Service Bulletin No: 30-007
Modification No: EC-24-0351

Ref No: 258
ATA Chapter: 30

**ICE AND RAIN PROTECTION - WINDOWS, WINDSHIELDS AND DOORS
MODIFICATION TO REPLACE THE LH WINDSHIELD HEATING SOLID STATE RELAY**

MSN 101 thru MSN 337 - Replace the LH Solid State Relay
Figure 1 (Sheet 1 of 9)

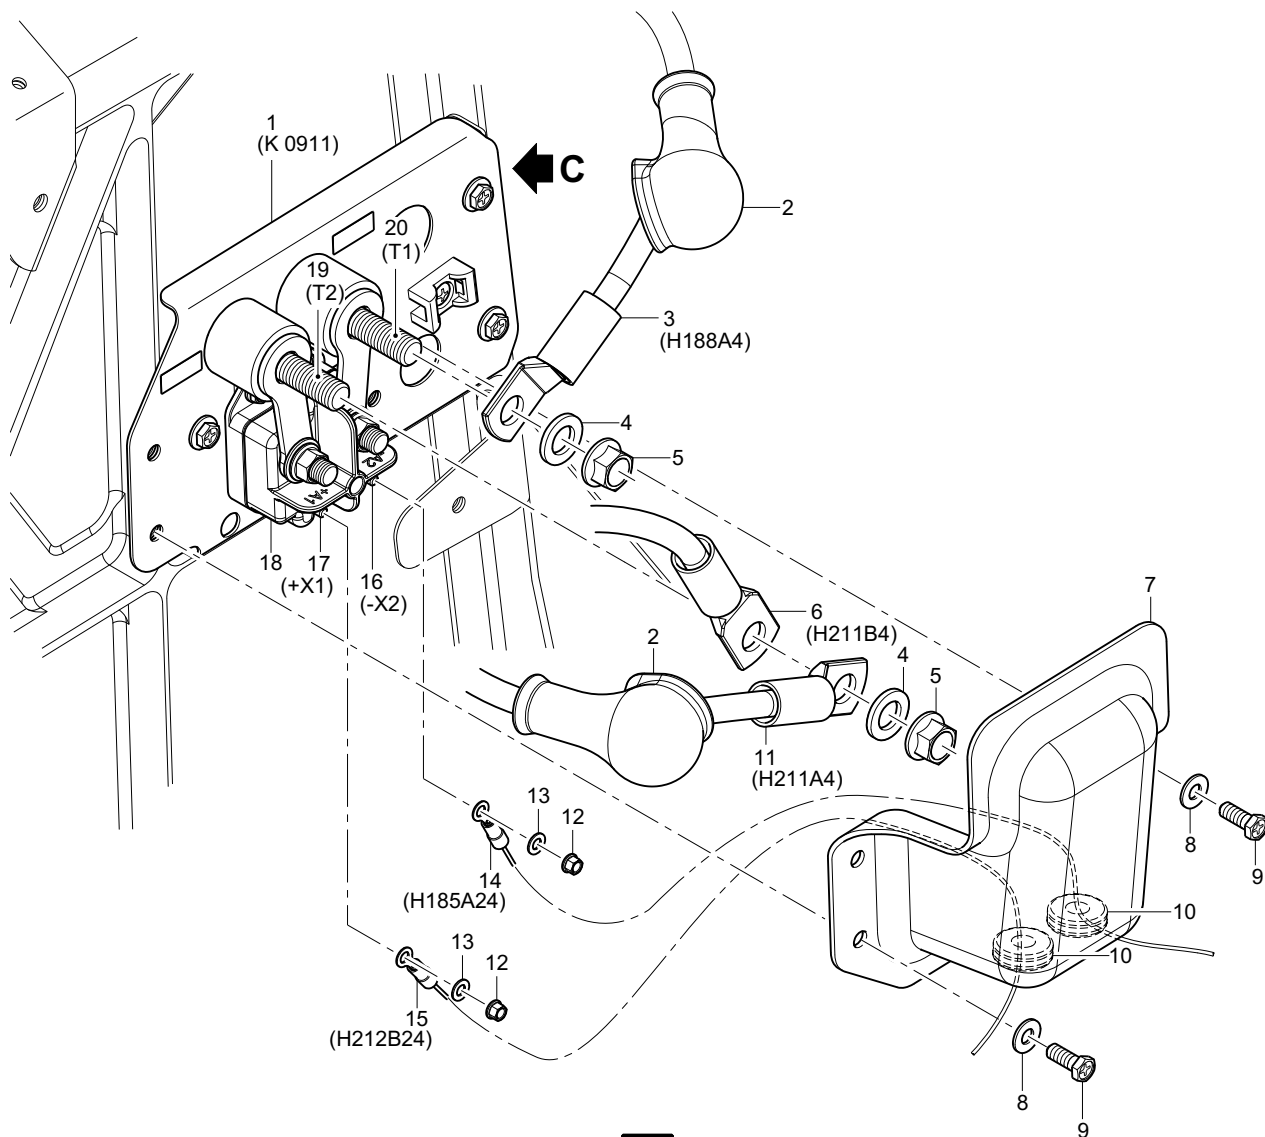
- Keep the screw (68)
 - Discard the washer (69).
- (o) Remove (and discard) the clamp (70) from the norm de-ice feeder cable H211B4 (6) and the LH de-ice feeder cable H196A4 (43).
Refer to Figure 1 (Sheet 1 and 8, View A and N (Pre SB)).

Refer to Figure 1 (Sheet 1 and 8, View A and M).

Refer to Figure 1 (Sheet 1, 8 and 9, View A, M and P).

- (aa) Put the new saddle (71) (P/N 971.32.18.122) in position on the structure near the SSR (29). Refer to Figure 1 (Sheet 1 and 8, View A and N (Post SB)).

MSN 101 thru MSN 337 - Replace the LH Solid State Relay
Figure 1 (Sheet 2 of 9)

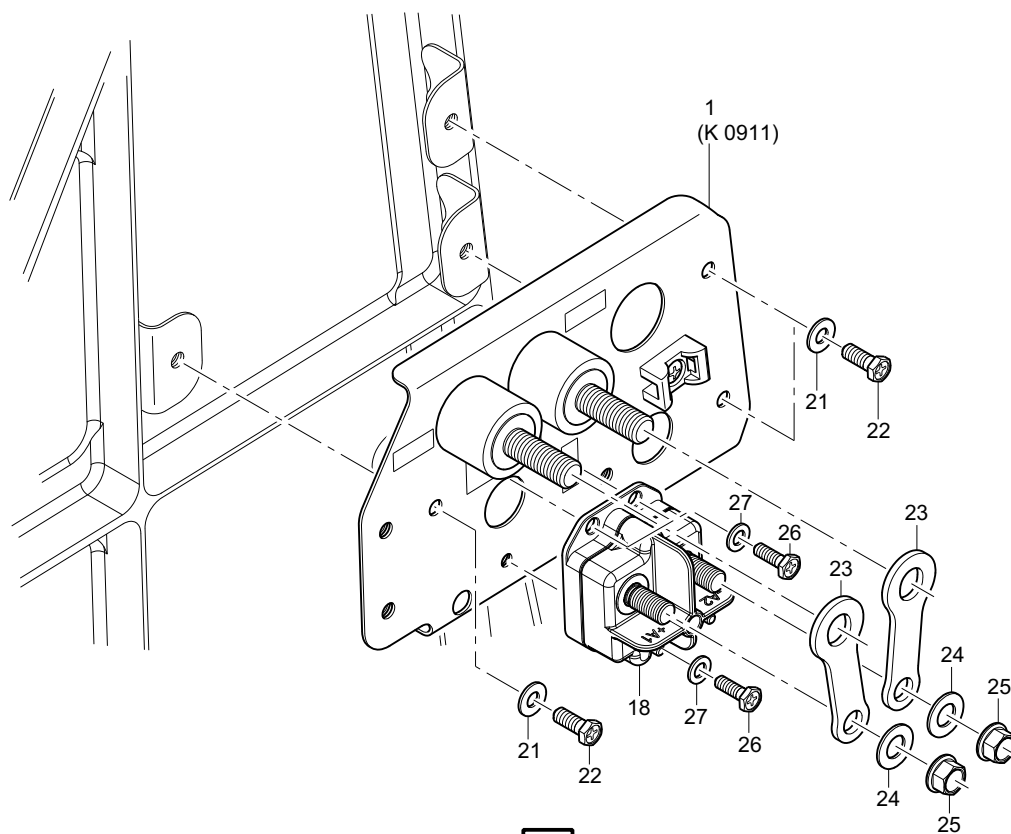
- (1) Remove the LH Solid State Relay (SSR) (18):
Refer to Figure 1 (Sheet 2 and 3)
 - (a) Remove (and discard) the four screws (9) and the four washers (8) that attach the cover (7) to the contactor panel K 0911 (1).

- (b) Move the cover (7) away from the contactor panel K 0911 (1) to get sufficient access to the SSR (18).
 - (c) Remove (and keep) the nut (12) and the washer(s) (13) from terminal +X1 (17) on the SSR (18).

- (d) Remove the terminal lug of electrical wire H212B24 (15) from terminal +X1 (17).
 - (e) Pull the electrical wire H212B24 (15) out of the fwd grommet (10) in the cover (7).

- (f) Remove (and keep) the nut (12) and the washer(s) (13) from terminal -X2 (16) on the SSR (18).
 - (g) Remove the terminal lug of electrical wire H185A24 (14) from terminal -X2 (16).

- (h) Pull the electrical wire H185A24 (14) out of the aft grommet (10) in the cover (7).
 - (i) Remove (and discard) the cover (7) (together with the grommets (10)) from the aircraft.

- (j) Cut and remove the cable ties that hold the two protective caps (2) in position on terminal T1 (20) and T2 (19) on the contactor panel K 0911 (1).

MSN 101 thru MSN 337 - Replace the LH Solid State Relay
Figure 1 (Sheet 3 of 9)

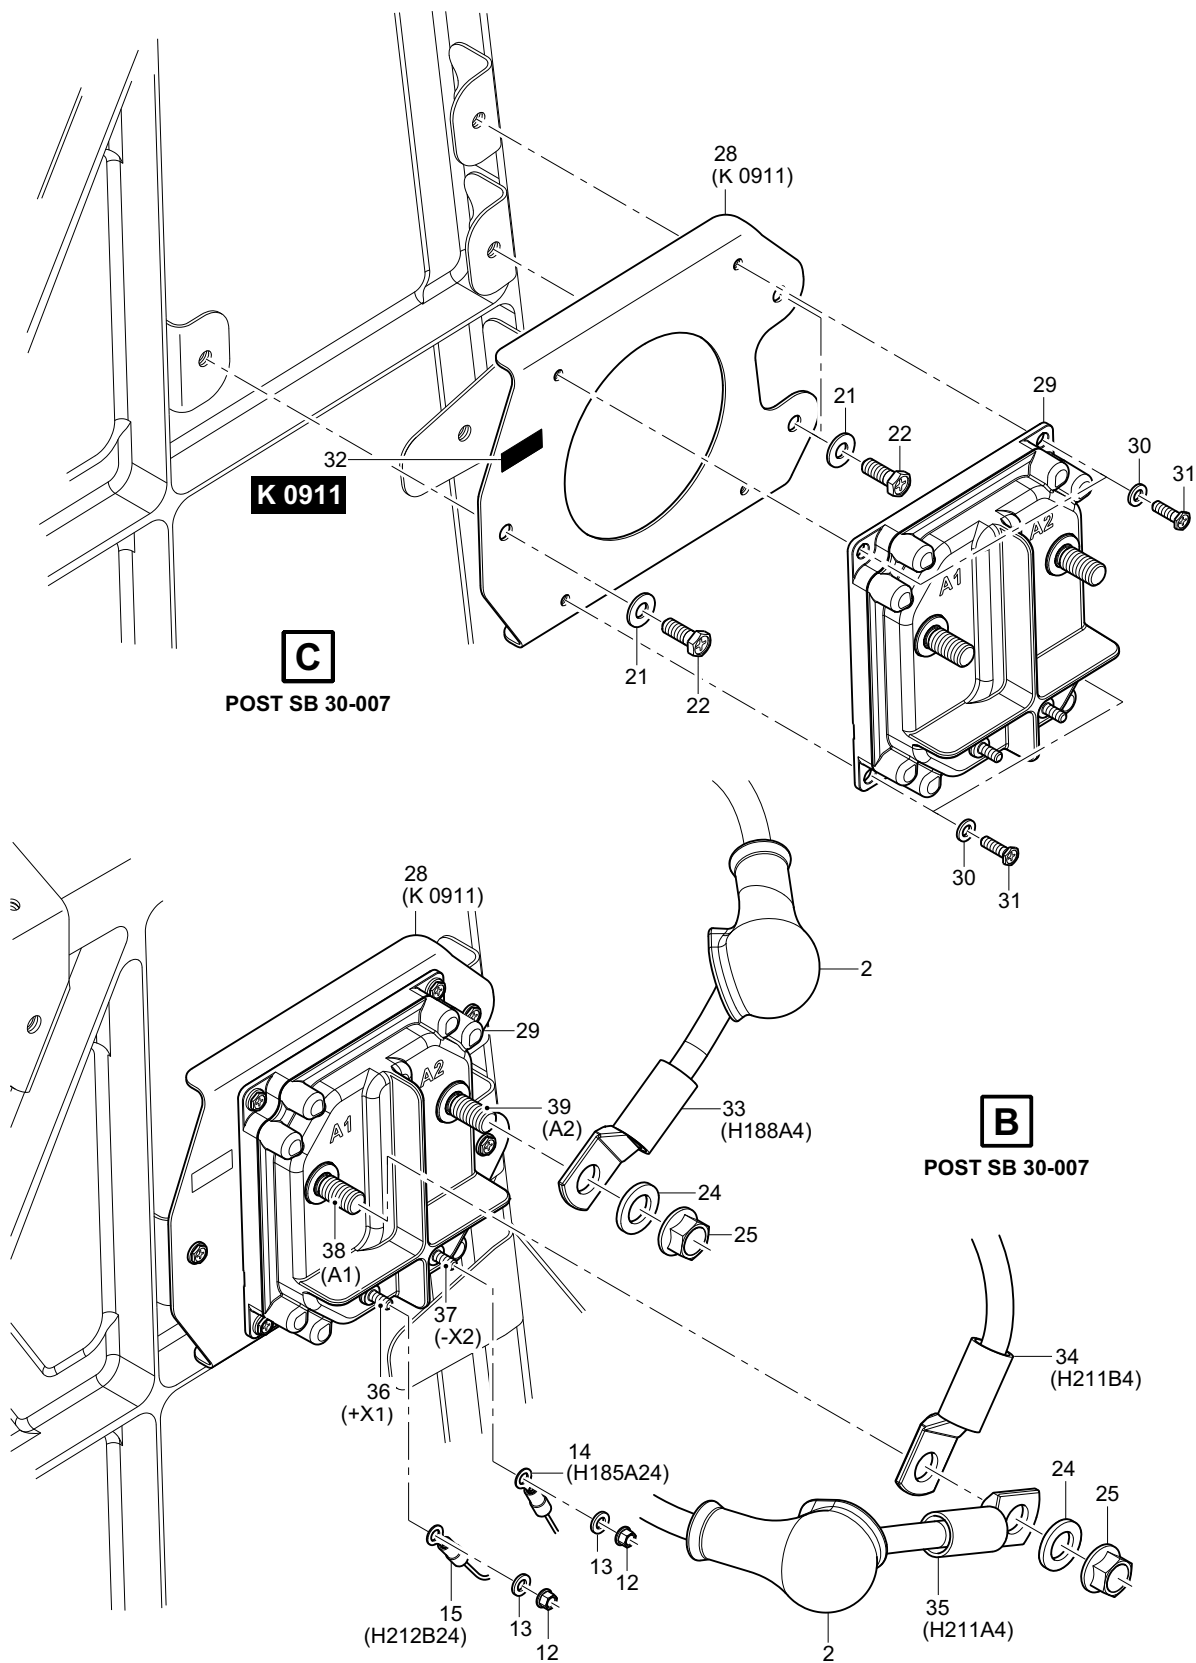
- (r) Remove (and keep) the three screws (22) and the three washers (21) that attach the contactor panel K 0911 (1) to the structure.
 - (s) Remove the contactor panel K 0911 (1) (together with the SSR (18)) from the structure.

- (t) Remove the SSR (18) from the contactor panel K 0911 (1):
- 1 Remove the two nuts (25), the two washers (24) and the two bus links (23) from the SSR (18):

- Keep the two nuts (25)
 - Keep the two washers (24)
 - Discard the two bus links (23).
 - 2 Remove the three screws (26), the three washers (27) and the SSR (18) from the contactor panel K 0911 (1).

MSN 101 thru MSN 337 - Replace the LH Solid State Relay
Figure 1 (Sheet 4 of 9)

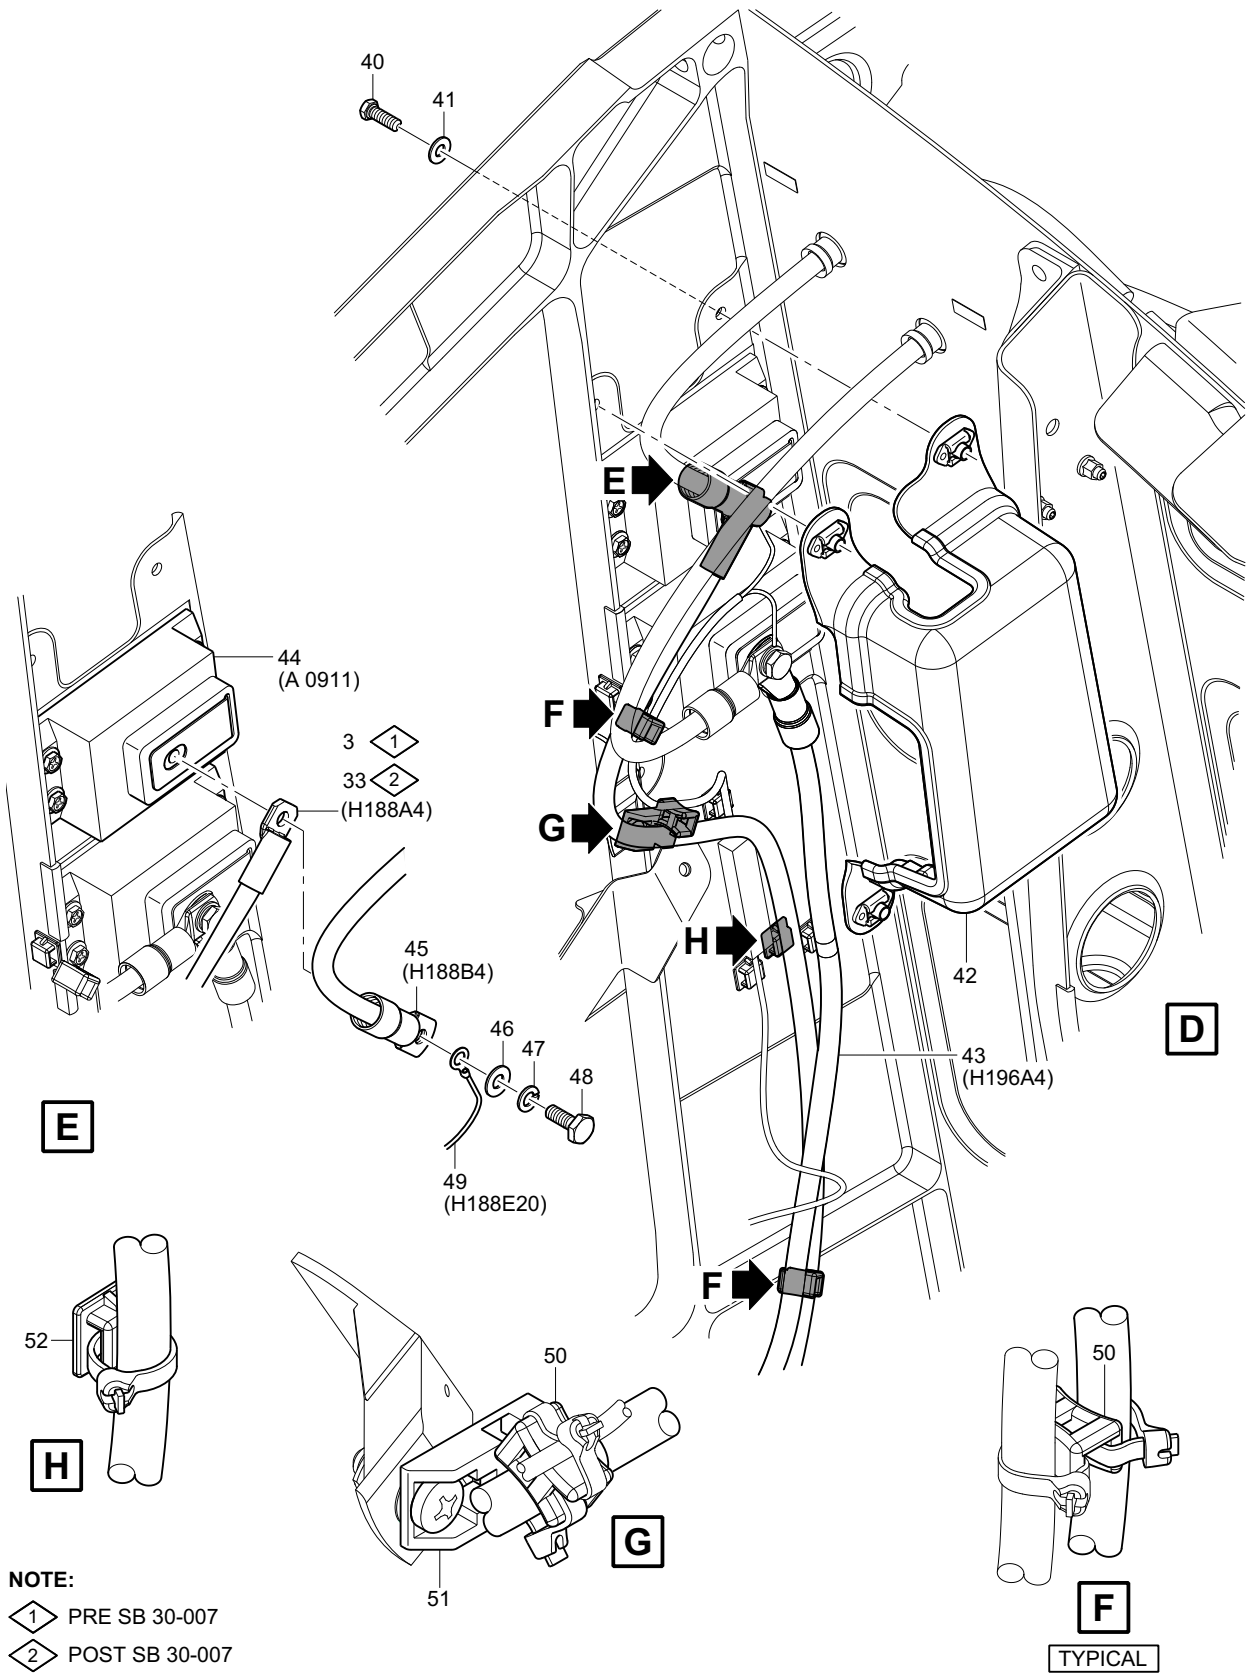
- (3) Install the new LH SSR (29):
Refer to Figure 1 (Sheet 4)
- (a) Clean the mating surfaces for electrical bonding on the:
- Structure
 - New contactor panel K 0911 (28) (P/N 524.60.24.144)

- New LH SSR (29) (P/N 974.20.01.235).
- Refer to AMM PC24-A-E20-60-0005-00A-913A-A.
- (b) Apply a thin layer of grease (Material No. P04-041) on the threads of the three screws (22) (that you kept).

- (c) Put the new contactor panel K 0911 (28) in position on the structure.
- (d) Install the three washers (21) (that you kept) and the three screws (22) to attach the contactor panel K 0911 (28) to the structure.

- (g) Put the new LH SSR (29) in position on the contactor panel K 0911 (28).
- (h) Install the four new washers (30) (P/N 938.77.10.007) and the four new screws (31) to attach the LH SSR (29) to the contactor panel K 0911 (28).

- 1 Clean the area where the new placard K 0911 (32) (P/N 511.35.24.941) is to be installed with absorbent paper (Material No. P02-031) made moist with isopropyl alcohol (Material No. P01-011).
Refer to Figure 1 (Sheet 4, View C).
- 2 Let the area dry.
- 3 Remove the backing strip from the new placard K 0911 (32).
- 4 Install the new placard K 0911 (32) in position on the contactor panel K 0911 (28). Make sure that no air bubbles are caught between the placard and the surface.

MSN 101 thru MSN 337 - Replace the LH Solid State Relay
Figure 1 (Sheet 5 of 9)

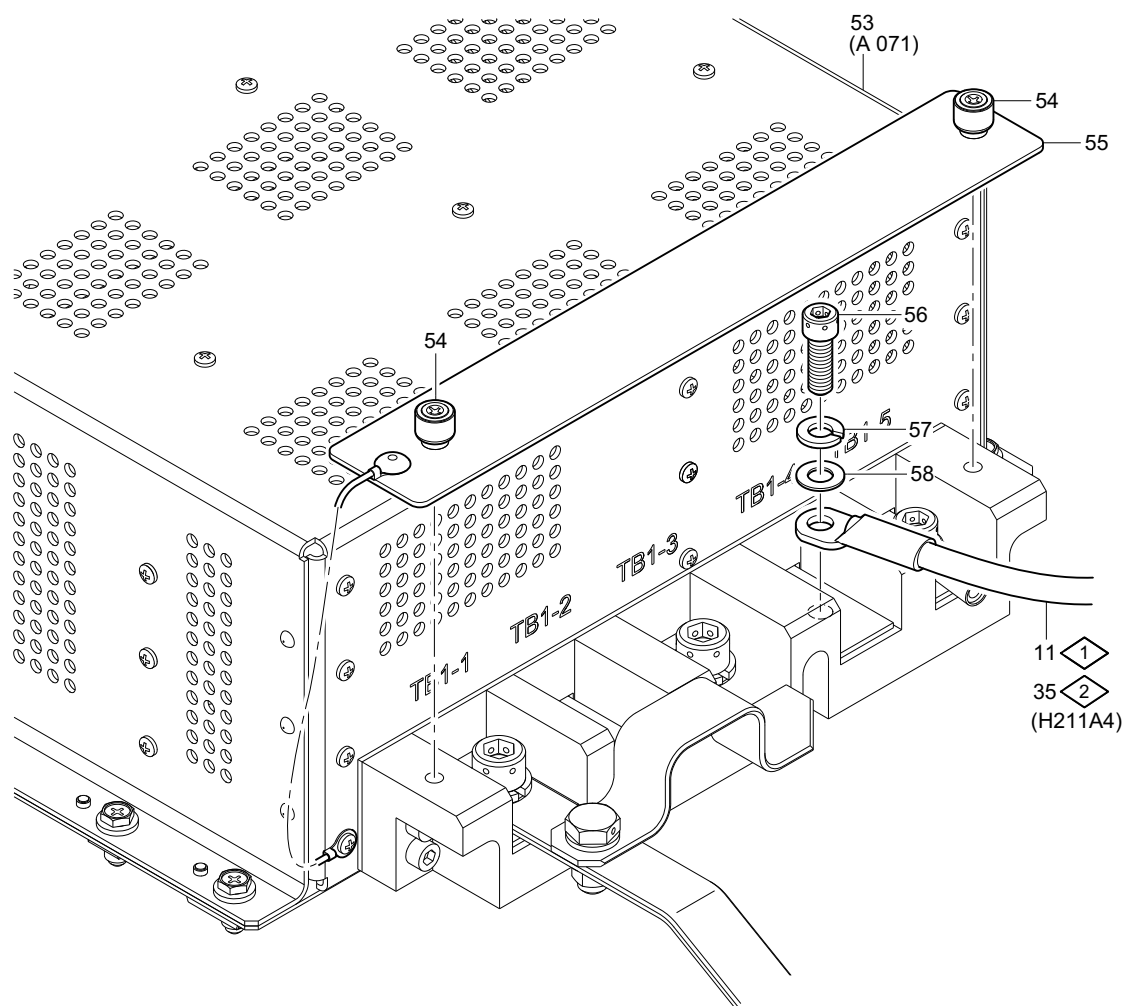
- LH de-fog cable H188A4 (3).
- (e) Cut and remove the cable ties that attach the LH de-fog cable H188A4 (3) (near Frame 10) to the:
- Spacer (50) and LH de-ice feeder cable H196A4 (43)

- Refer to Figure 1 (Sheet 5, View F, G and H).
- (f) Loosen the two captive screws (54) that attach the terminal block cover (55) to the EPDU 1 (A 071) (53).

- (d) Torque the bolt (48) to a maximum of 13 lbf in (1,5 Nm). Make sure that the terminal lugs do not turn or bend.
- (e) Use the applicable cable ties (Material No. P09-140) to attach the LH de-fog cable H188A4 (33) (near Frame 10) to the:

Refer to Figure 1 (Sheet 5, View F, G and H).

MSN 101 thru MSN 337 - Replace the LH Solid State Relay
Figure 1 (Sheet 9 of 9)

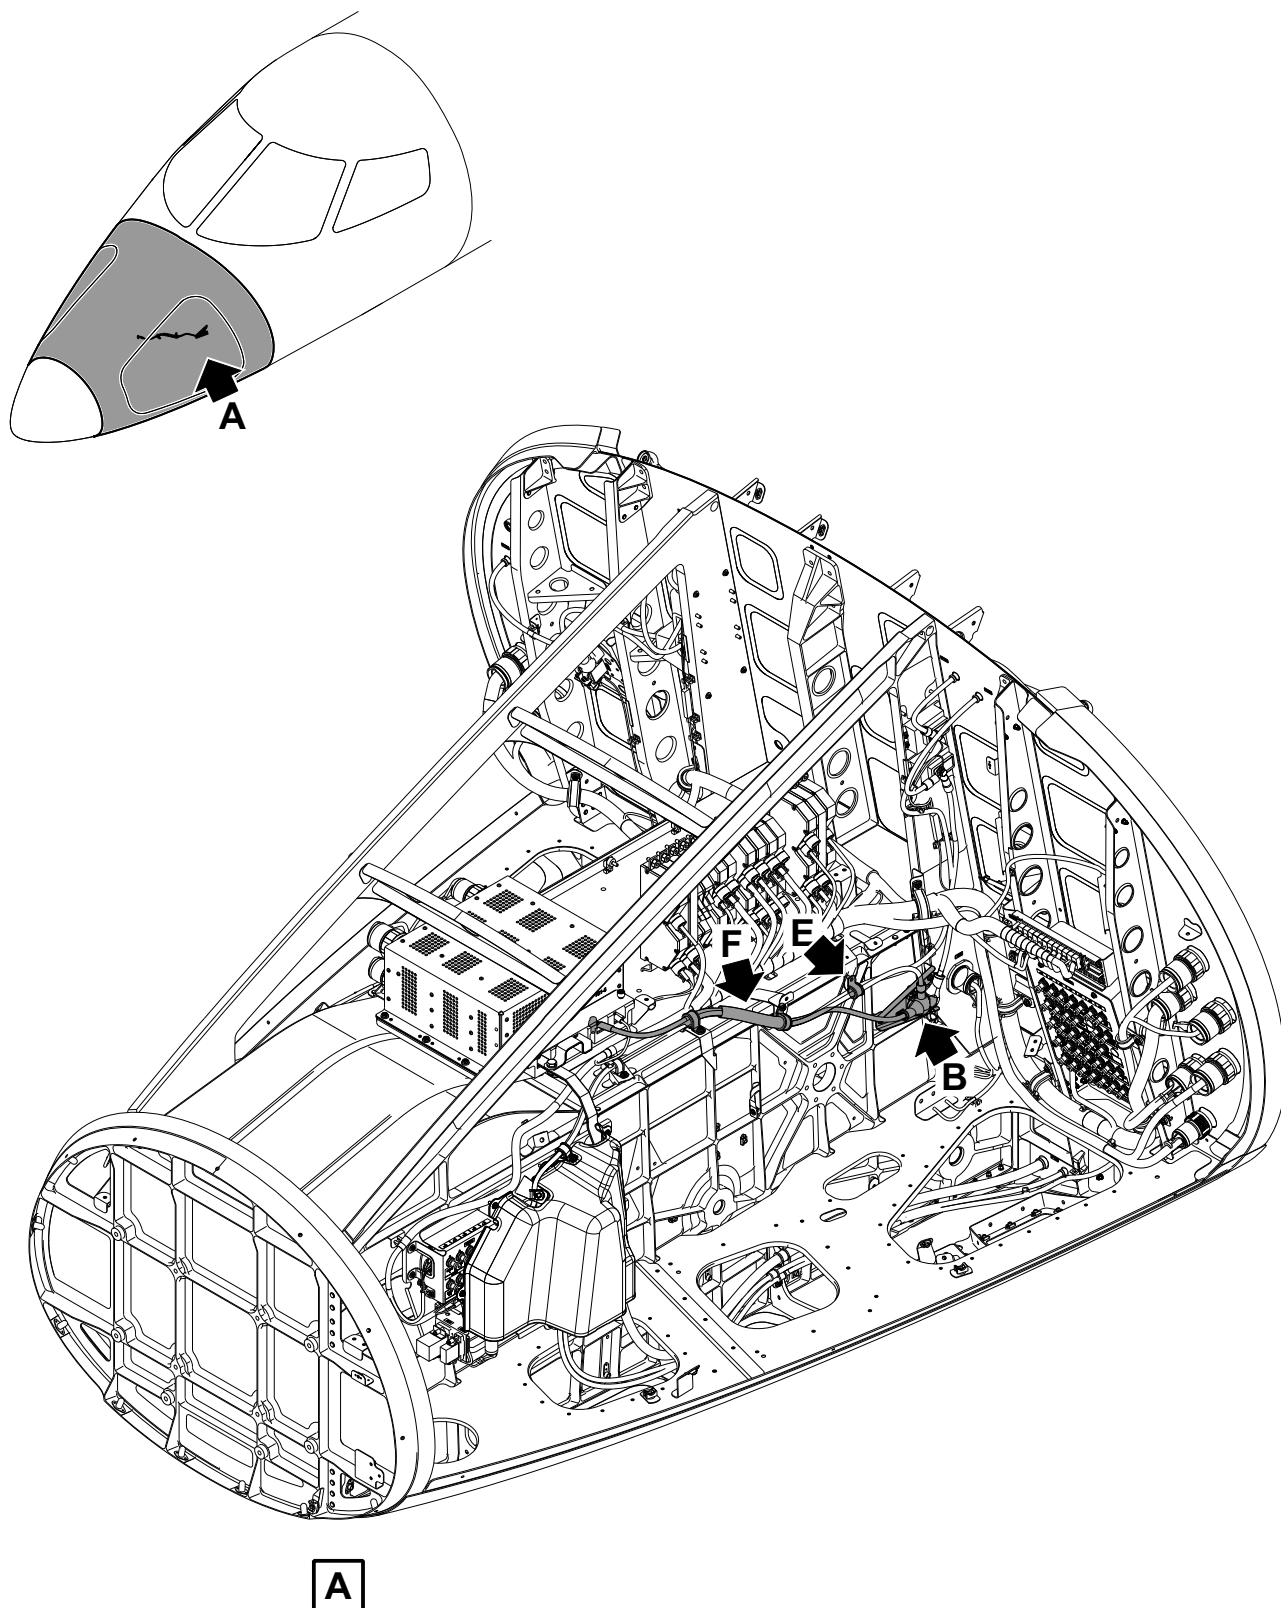
Refer to Figure 1 (Sheet 1, 8 and 9, View M and P).

- (l) Loosely route the new norm de-ice feeder cable H211B4 (34) (P/N 591.50.24.099):
 - Thru the protective sleeve (72)
Refer to Figure 1 (Sheet 1 and 9, View P)

- Thru the protective sleeve (72)
Refer to Figure 1 (Sheet 1 and 9, View P)
 - Between the LH SSR (29) and terminal TB1-4 on the EPDU 1 (A 071) (53).
- (q) Put the terminal lug of the feeder cable H211A4 (35) in position on terminal TB1-4 on the EPDU 1 (A 071) (53).
